**PREVOST**

**SAFETY  
RECALL**

**SR22-05**

DATE :	September 2022	SECTION :	06 ELECTRICAL
SUBJECT:	ALTERNATOR BELTS REPLACEMENT

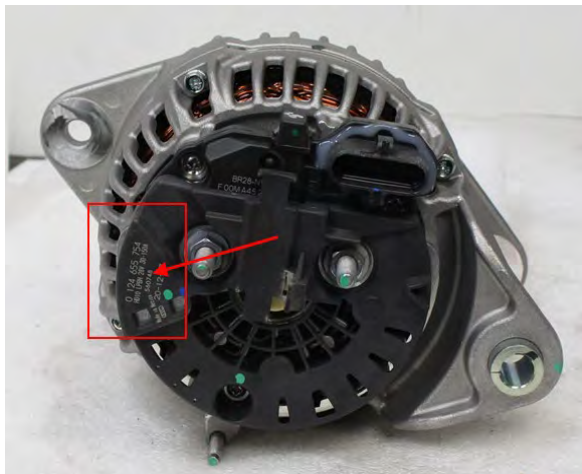
1. On vehicle equipped with a mechanical cooling fan, remove the fan belt.
2. Remove the left hand alternator belt (if so equipped)
3. Remove both AC V-belts (manual tensioner)

- Slack the manual adjustment screw.
  - Remove the tensioner.
  - Remove the belts.
4. Remove the water pump belt.
  5. Remove the right hand alternator(s) belt.
  6. Spin all alternators and make sure no bearing noises are coming from the alternator(s). Replace alternator(s) as needed (Only OEM alternator(s) with noisy bearings are covered by this safety recall; See *OEM Alternator Identification* below).

7. Reverse the procedure to reinstall the belts on the vehicle.

### REMY 55S

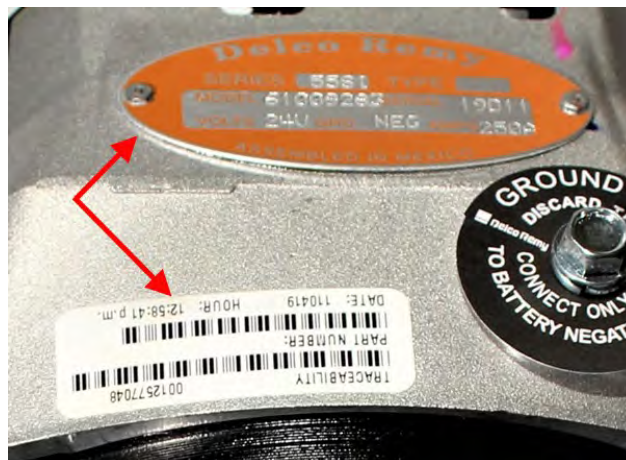
- REMY 55S Alternator will have a Delco-Remy identification plate riveted to the body as well as a bar code sticker next to the ground stud as shown.
